ENGINE - POWER PLANT - EEC HARNESS FAN - FCOC FUEL TEMPERATURE THERMOCOUPLE CONNECTOR  
WITH IMPROVED SOCKETS - CATEGORY CODE 4 - MOD.ENG-71-0160

V2500-ENG-71-0160

Location of 401KS-A connector  
Fig.1

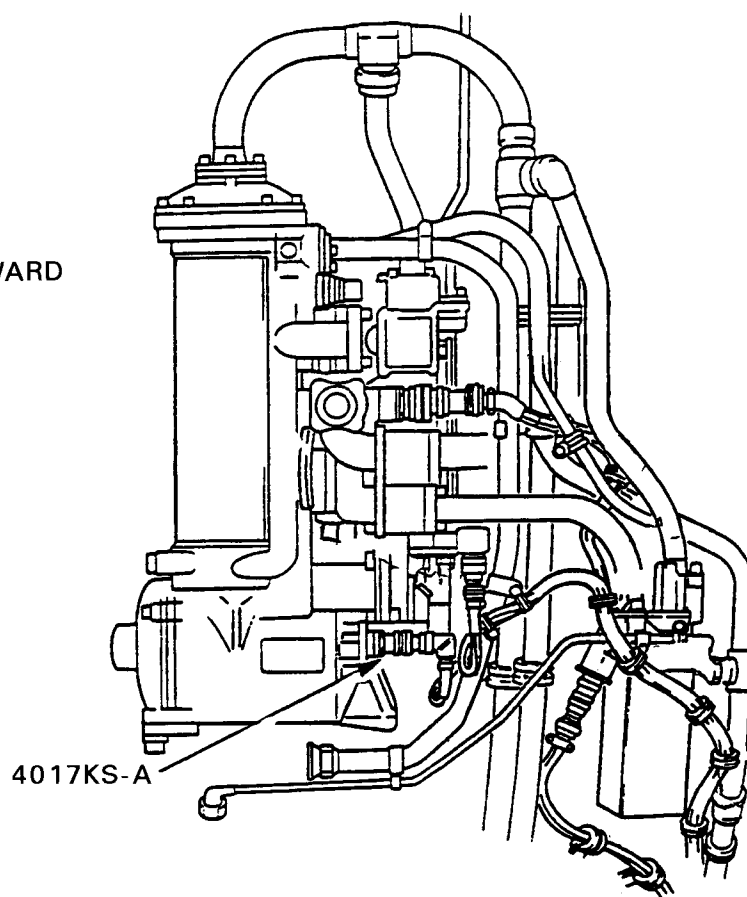
- (1) Disconnect the EEC Fan harness electrical connector (4017KS-A) from the fuel temperature thermocouple on the FCOC. Refer to Figure 1.

- (1) Connect the 4017KS-A electrical connector to the fuel temperature thermocouple on the FCOC and torque to 100 to 120lbfin (11,3 to 13,6 Nm). Refer to Figure 1.

Family tree - Harness assembly, E.E.C. fan Illustrated parts Catalog Ref, 71-51-41,  
Fig.01 Item 005  
Fig.2

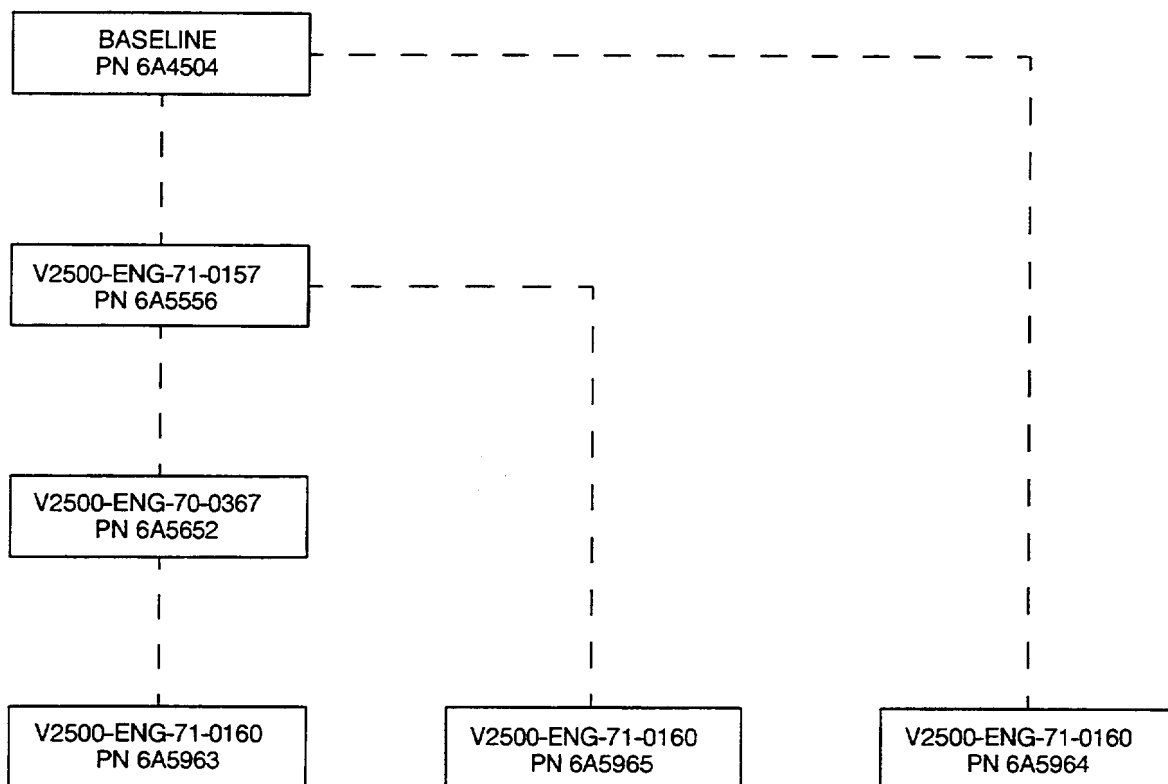
This Service Bulletin introduces a new EEC fan harness with the existing two-point contact sockets in the FCOC fuel temperature connector (4017KS-A) replaced by four-point contact sockets with a napkin band retention feature. Existing harnesses may be reworked.

- (1) Remove the ESC30S16NC sockets from contact positions 2 and 5 of the 4017KS-A selectrical connector and replace with the new BT4116-10PY165 or BT4116-10P sockets. Use the approved procedure in Reference (1), Chapter/Section 71-50-21.
- (2) Remove the ESC30S16NA sockets from contact positions 3 and 6 of the 4017KS-A electrical connector and replace with the new BT4116-10RY165 or BT4116-10R sockets. Use the approved procedure in Reference (1), Chapter/Section 71-50-21.
- (3) Cancel the existing EEC Fan Harness part number and identify with the new part number by applying two turns of V02-148 Adhesive Tape (Electrical) and marking the new part number using a black ball point pen.
